AON SPRINKLER CERTIFICATION

Aon Sprinkler Certification Technical Note

Note Number: TN-20-45	Issue: 1.1	Date: 19 August 2020
Subject	Pump House Pipe Work	
Notice: Aon Sprinkler Certification Technical Notes provide guidance notes which may be used in certification of sprinkler installations by Aon New Zealand. If sprinkler installations are being certified by any other Sprinkler System Certifier, these Technical Notes may not apply.

This photograph shows bracing on a 200mm pipe in a pump house.

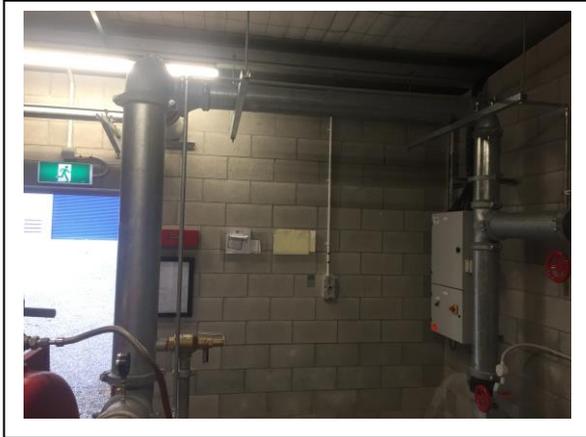
- The method of attaching the brace is best described as interesting. We are unaware of any published data showing the load capacity of a 45°-malleable iron elbow.
- Under NZS4541:2020, the pipe clamp itself will require to be listed for seismic bracing.
- While not shown in the photograph, the pipework is not provided with any longitudinal seismic bracing.
- One could question why an investigation was not carried out to check if the lateral brace could have simply been fixed to the block wall.
- With a tall skinny column there is risk of buckling.

This photograph shows a pipe support which appears to be fabricated out of “Unistrut” type channel.

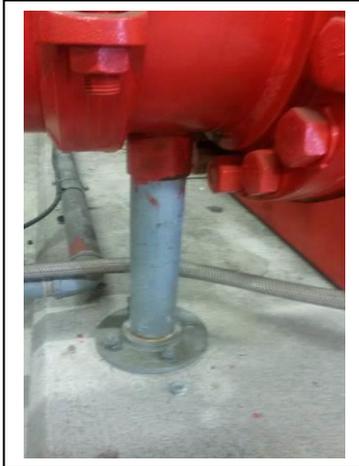
Intuitively, it appears to be too light to act as a column and is probably being supported by the pipe.

A support such as this should be designed by an engineer, accounting for gravity, seismic and thrust loads.
